This is output from your simulation without any changes.

**So lets step through your process and make necessary changes.....**

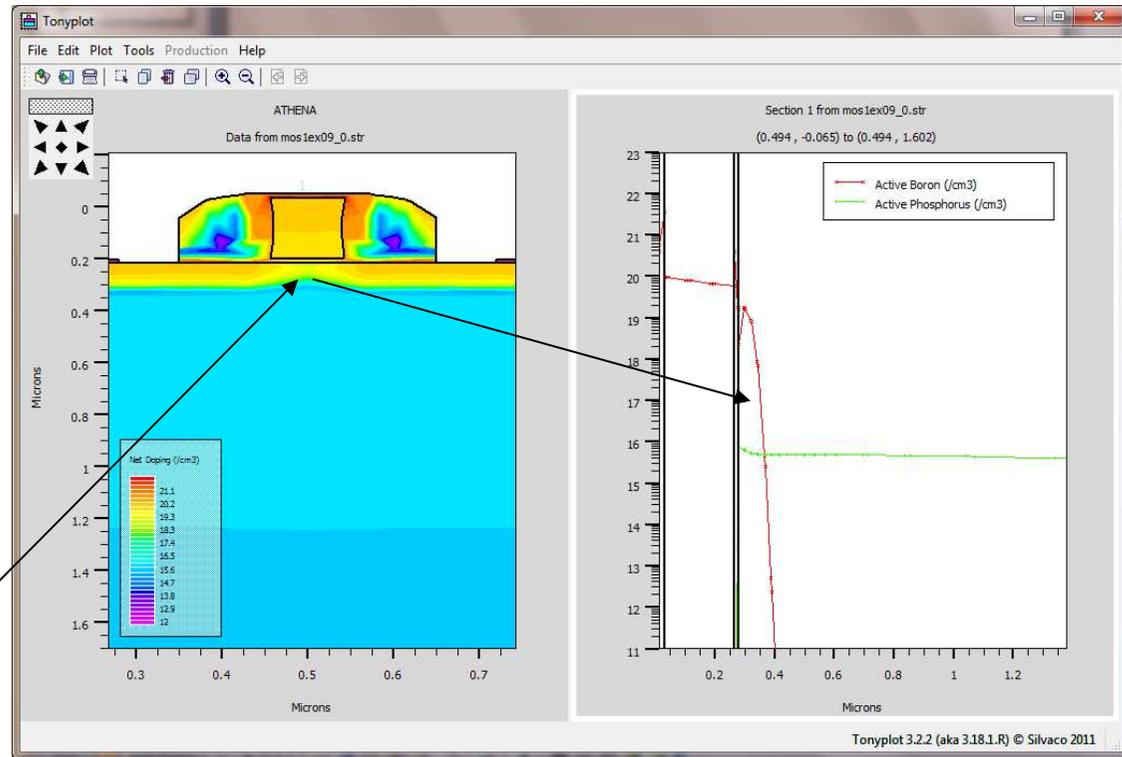
First look a physical cross section.

- (1) The spacers are far too wide turning your 9.5nm transistor into a 29.8nm transistor. That is like stepping back 5 generations of transistor. So the spacer has to be changed.
- (2) The profile of the poly gate is not good. This is due to the wet oxidation done after the poly is etched. This would never be done on even 0.25um technologies so this has to change.
- (3) Look at the doping beneath the poly (the channel of the transistor). It looks like the source and drain implants are shorted beneath the poly. The cut line graph of doping confirms there is boron in the channel. This is because you use bf2 for the threshold adjust implant.

Bf2 is a threshold adjust implant for an nmos transistor not a pmos. Pmos would use phosphorous.

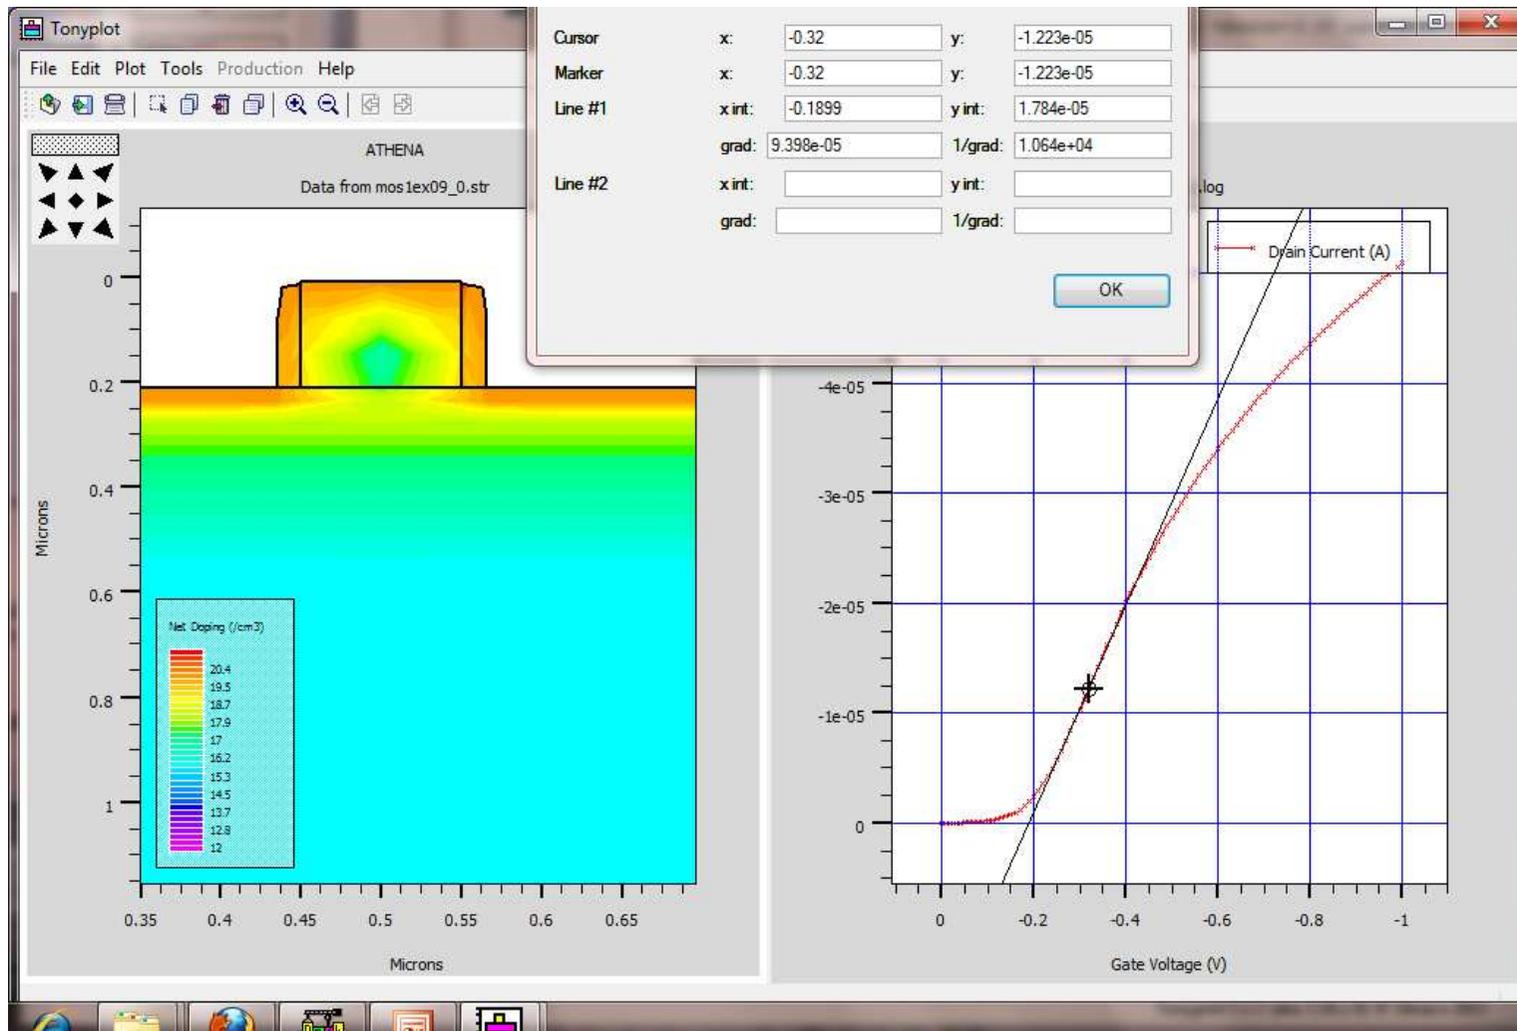
Now you must admit this looks better. Gate oxide is 15 Angs,  $V_T$  is 185mV

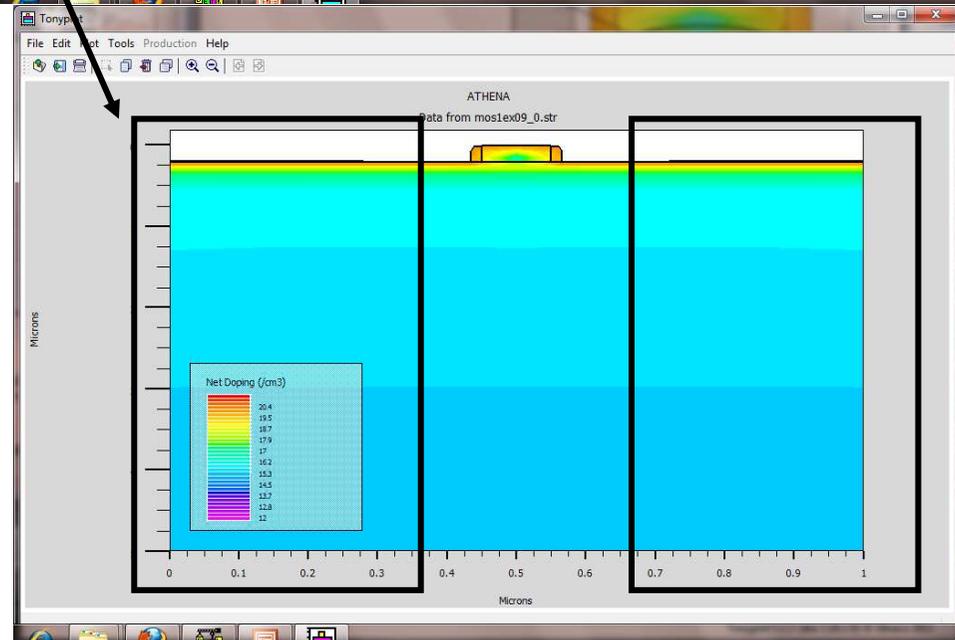
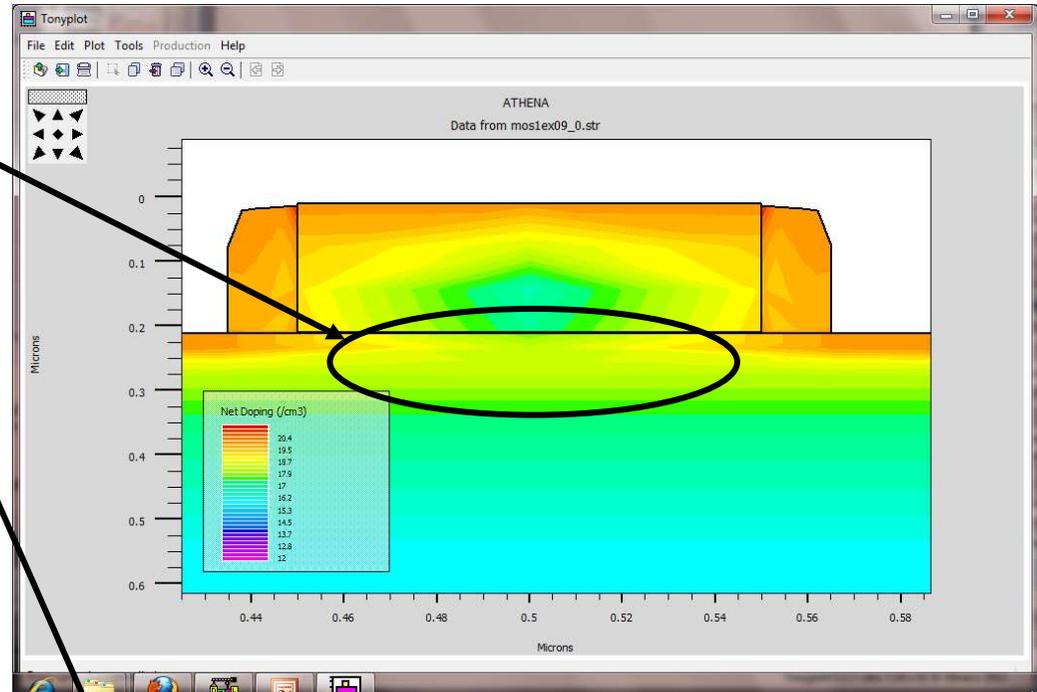
Look at how ragged the contours are in the channel here.

This is because the mesh is not very good.

Also look at the wasted space either side of the gate poly.

We only need about 0.2um either side of the poly edge.

Ah... much more beautiful and more realistic. But it is now showing up a real problem with this process. Look at the contours inside the poly. There is no doping near the poly/gate oxide interface. So the poly will be undoped here and will act as an insulator. This did not show up on the previous code because the mesh was not accurate enough.

Changing the as follows:

```
line x loc=0.00 spac=0.1  
line x loc=0.10 spac=0.005  
line x loc=0.20 spac=0.005  
line x loc=0.45 spac=0.01  
#  
line y loc=0.00 spac=0.005  
line y loc=0.1 spac=0.015  
line y loc=0.5 spac=0.02  
line y loc=2 spac=0.2
```

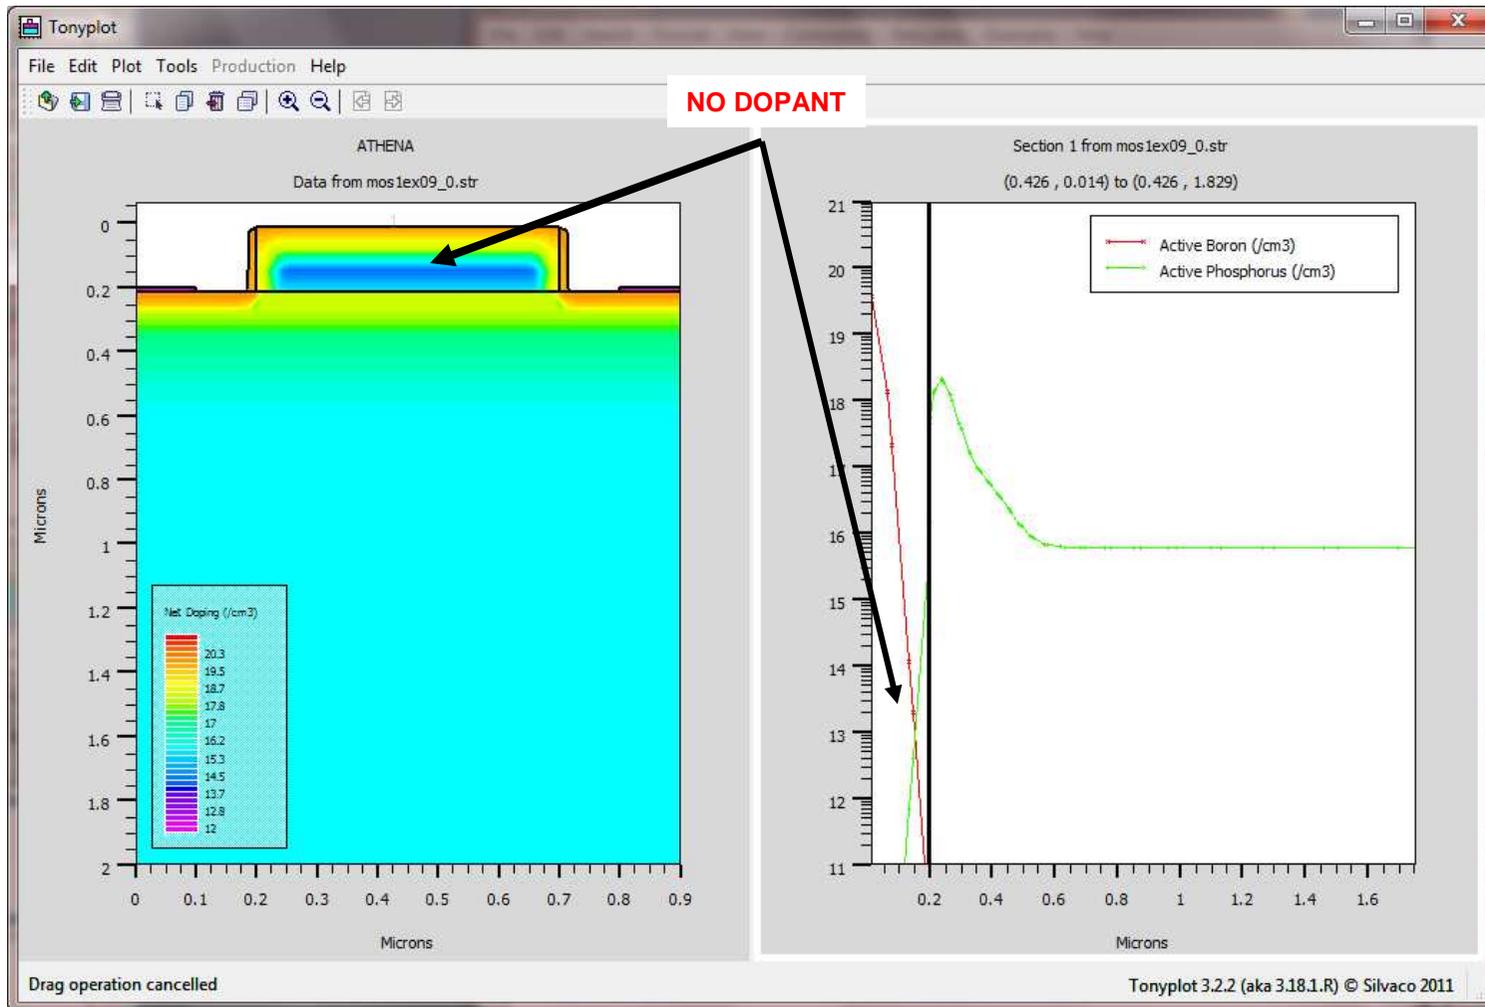
The graph on the right shows the boron profile (RED) in the poly drops to very low close to the surface of the wafer!! This device will not work because the 90nm P+ must be a shallow implant, but it is too shallow to dope the poly.

The only way to fix this is to dope the poly after it is deposited before etch.

```
depo poly thick=0.200 div=3  
implant amorphous boron dose=1.0e15 energy=25 pearson  
#  
etch poly left p1.x=0.2
```

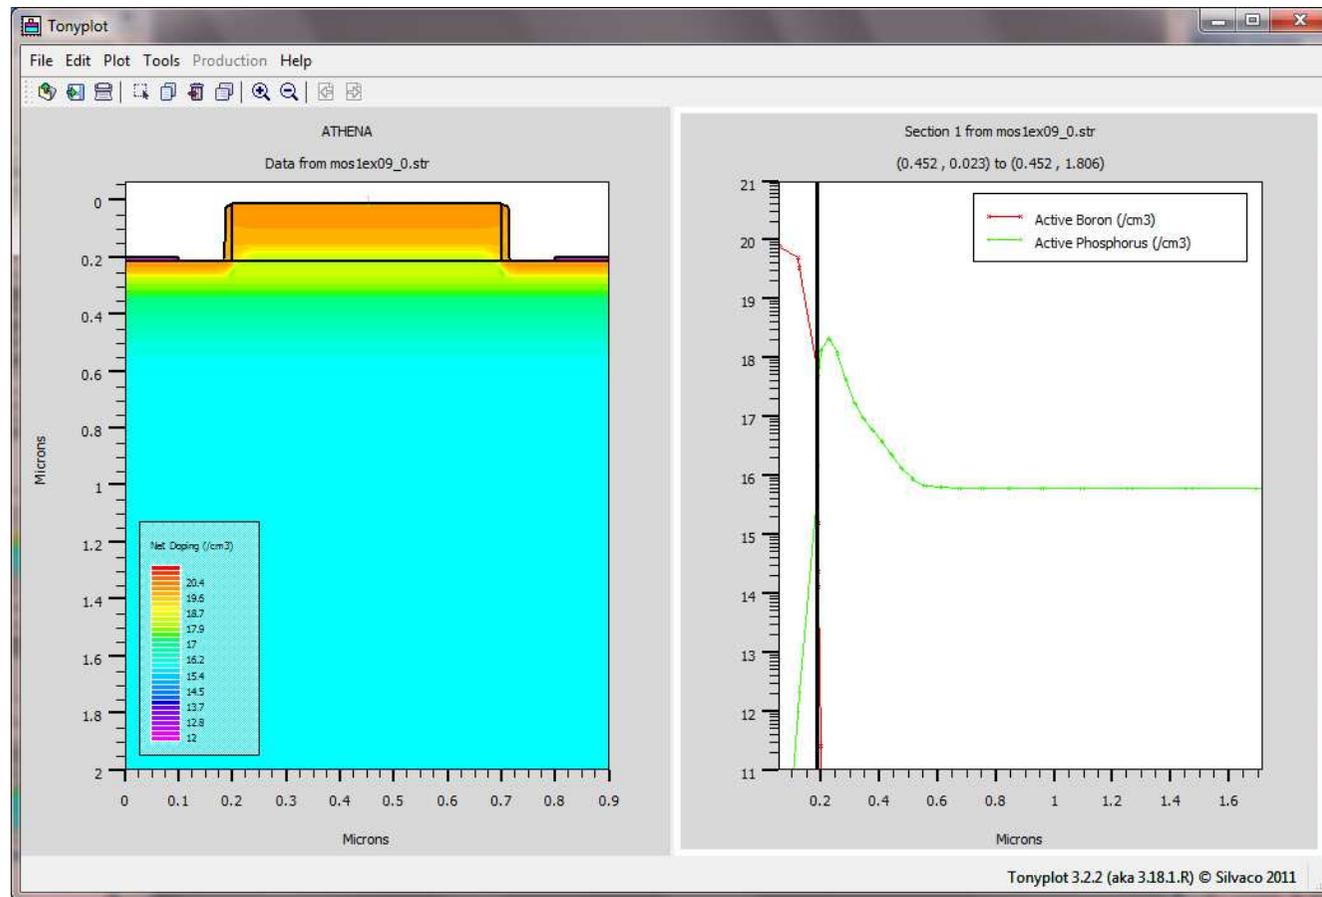
Now see the difference: The poly is fully doped

So this is more accurate, but there is a consequence of this increased accuracy. Without changing anything else, the VT has increased to almost 200mV. So the VT adjust implant will need to be fine tuned.
